Process Change Notification

Product type : 6mm Square Thin Type SMD LTSW
Product Part No. : Refer applicable part no. table.
Change Item : Change date code display marking from punch method to laser method.
Purpose : Quality improvement for marking appearance and enhance traceability.
Detail : Refer diagram below: -

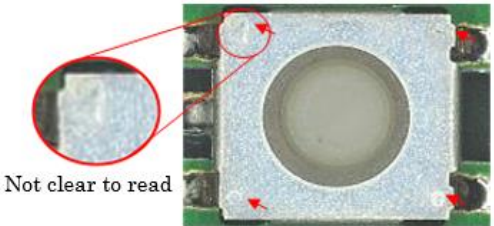
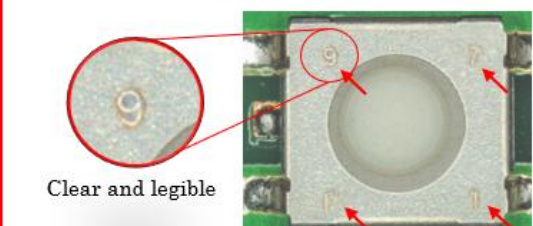
Change Content	Current type	New type																											
Date Code Display	<p><u>Marking by punch</u></p>  <p>Not clear to read</p>	<p><u>Marking by laser</u></p>  <p>Clear and legible</p>																											
Marking content	<p><u>Not specified day and machine number</u></p>  <table border="1"> <thead> <tr> <th>Mark</th> <th>Indication</th> <th>Example</th> </tr> </thead> <tbody> <tr> <td>y</td> <td>Produced Year</td> <td>2020 → 0</td> </tr> <tr> <td>M</td> <td>Produced Month</td> <td>Jan~Sep → 1~9 Oct → O, Nov → N, Dec → D</td> </tr> <tr> <td></td> <td>Product Date</td> <td>① The first ten days of a month ② The middle of the month ③ The last ten days of the month</td> </tr> </tbody> </table>	Mark	Indication	Example	y	Produced Year	2020 → 0	M	Produced Month	Jan~Sep → 1~9 Oct → O, Nov → N, Dec → D		Product Date	① The first ten days of a month ② The middle of the month ③ The last ten days of the month	<p><u>Specified production day and machine number</u></p>  <table border="1"> <thead> <tr> <th>Mark</th> <th>Indication</th> <th>Example</th> </tr> </thead> <tbody> <tr> <td>y</td> <td>Produced Year</td> <td>2020 → 0</td> </tr> <tr> <td>M</td> <td>Produced Month</td> <td>Jan~Sep → 1~9 Oct → O, Nov → N, Dec → D</td> </tr> <tr> <td>D</td> <td>Produce Day</td> <td>1st~9th → 1~9, 10 → 0 11th~31st → A~W (without I,O)</td> </tr> <tr> <td>M/C</td> <td>Machine No.</td> <td>M/C No.1 → 1 ...</td> </tr> </tbody> </table>	Mark	Indication	Example	y	Produced Year	2020 → 0	M	Produced Month	Jan~Sep → 1~9 Oct → O, Nov → N, Dec → D	D	Produce Day	1st~9th → 1~9, 10 → 0 11th~31st → A~W (without I,O)	M/C	Machine No.	M/C No.1 → 1 ...

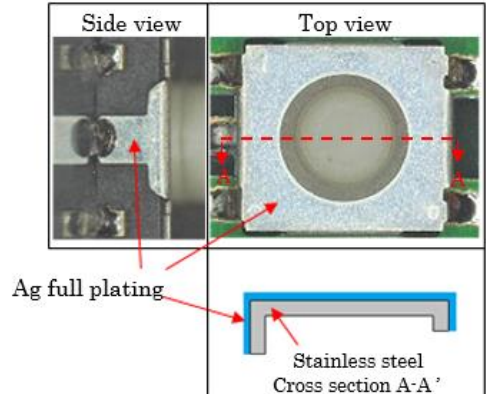
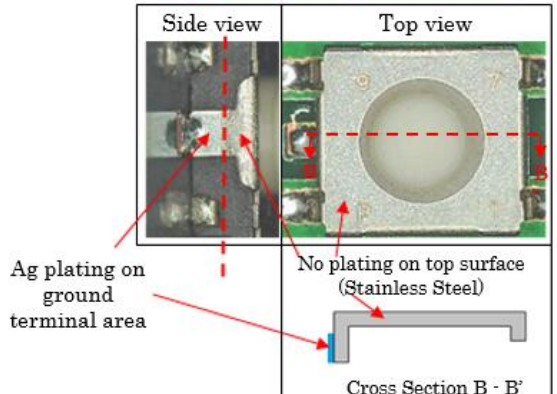
Mark	Indication	Example																											
y	Produced Year	2020 → 0																											
M	Produced Month	Jan~Sep → 1~9 Oct → O, Nov → N, Dec → D																											
	Product Date	① The first ten days of a month ② The middle of the month ③ The last ten days of the month																											
Mark	Indication	Example																											
y	Produced Year	2020 → 0																											
M	Produced Month	Jan~Sep → 1~9 Oct → O, Nov → N, Dec → D																											
D	Produce Day	1st~9th → 1~9, 10 → 0 11th~31st → A~W (without I,O)																											
M/C	Machine No.	M/C No.1 → 1 ...																											
Related Part Change (Metal Cover)	<p><u>Ag full plating on metal cover</u></p>  <p>Ag full plating</p> <p>Stainless steel Cross section A-A'</p>	<p><u>Ag partial plating on metal cover</u></p>  <p>Ag plating on ground terminal area</p> <p>No plating on top surface (Stainless Steel)</p> <p>Cross Section B - B'</p>

MARKING CHANGE METHOD AND PARTIAL Ag PLATED WILL NOT AFFECT MECHANICAL AND ELECTRICAL SPECIFICATION
